# **Record of Decision**

**Defense National Stockpile Center Scotia**

**State Superfund Project**

**Site Number 447023**

**FIGURE 3**  
**Conceptual Illustration of Selected Remedial Alternative**

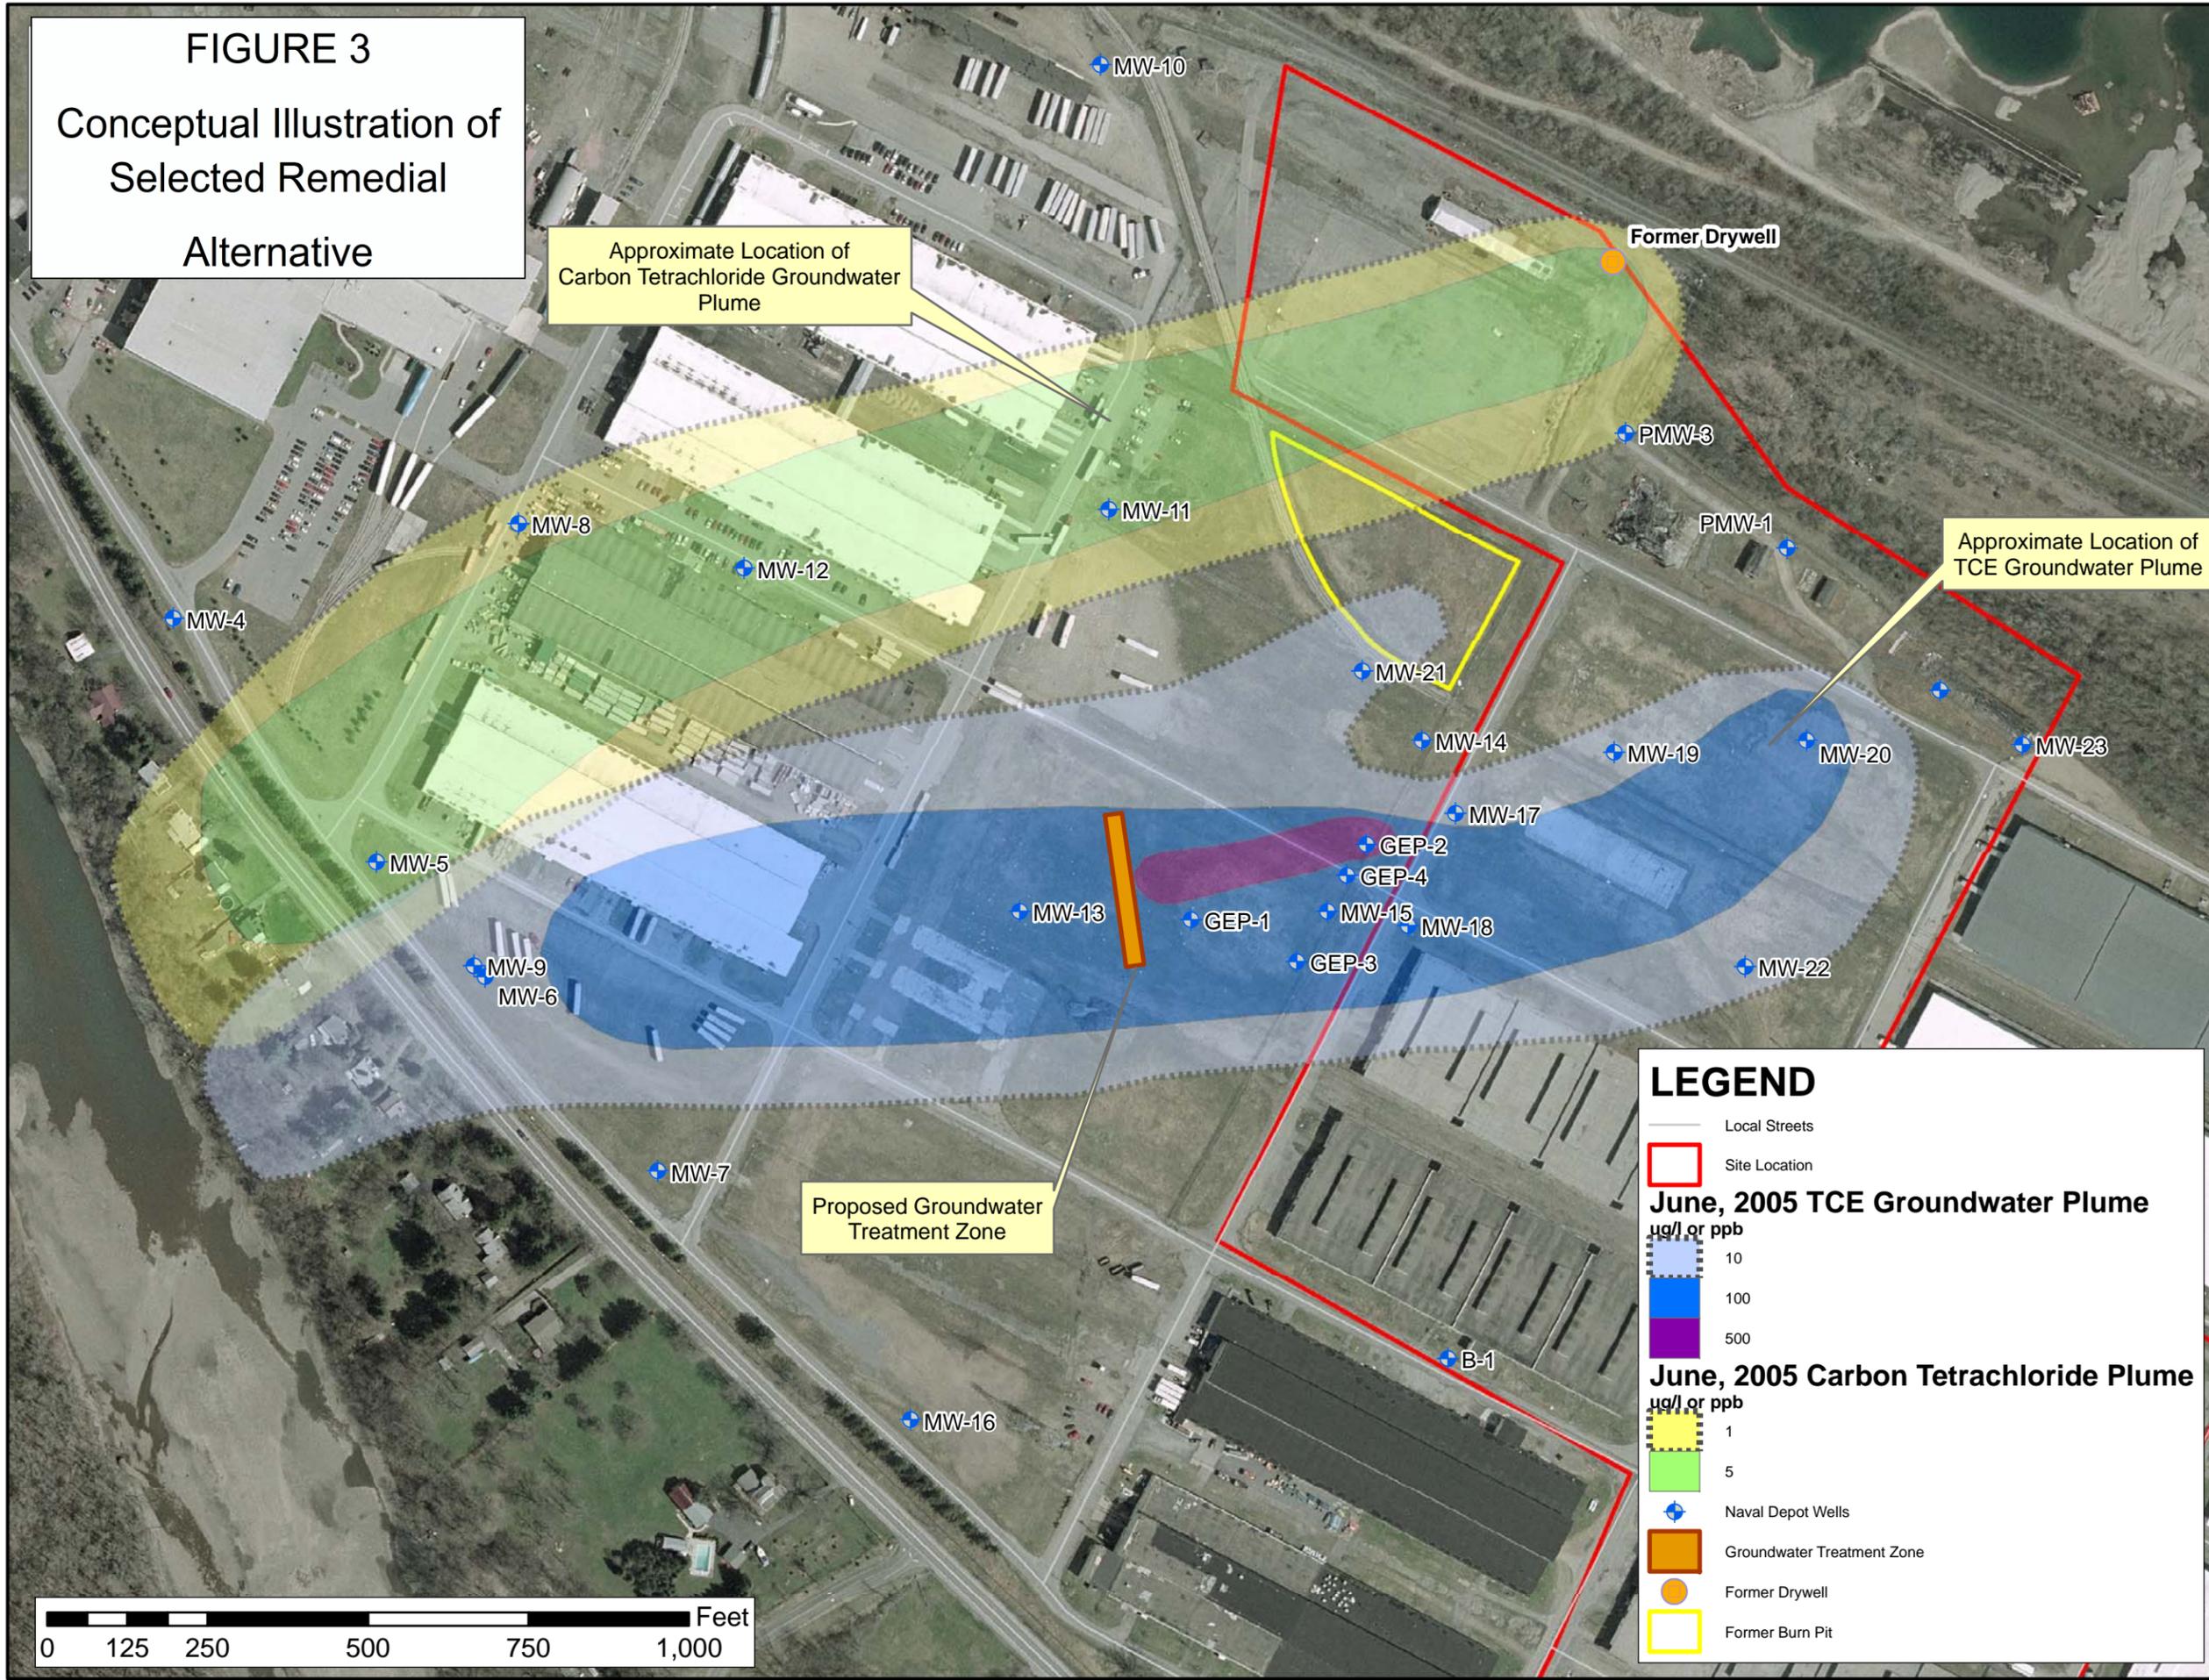
**COMMENT 2:** Can you explain what exactly the plume is?

In particular, Beacon Power Corporation currently has an option on 4.5 acres of land in the Park, the majority of which falls in the Proposed Groundwater Treatment Zone as outlined in Figure 3 (Figure 3 of the ROD). While we feel that Beacon's project should not be adversely impacted by NYSDEC's remedial actions, in order to protect the interests of our tenant we need to be involved with all phases of the plan. Therefore, we propose that a meeting be scheduled as soon as possible so that we can fully disclose to NYSDEC all information in our possession so as to allow your proposed remediation project to proceed as scheduled without undue interference with the business arrangements in place at the Park.

**RESPONSE 2:** The plume as shown in the PRAP presentation figures refers to an area where the site contaminants (TCE, 1,1,1-TCA, PCE, and carbon tetrachloride) are dissolved in groundwater beneath the site at a depth of approximately 60 feet to 65 feet beneath the ground surface. A visual depiction of the groundwater plume is shown on Figure 3 of the ROD.

**RESPONSE 25:** During the investigation at the site and during development of the PRAP, the Department routinely met with Schenectady County and Town of Glenville Staff. The comment is noted and Department staff will contact the tenants (Galesi Group) to schedule a meeting in order to work out implementation of the remedy in the area of the 300 Block.
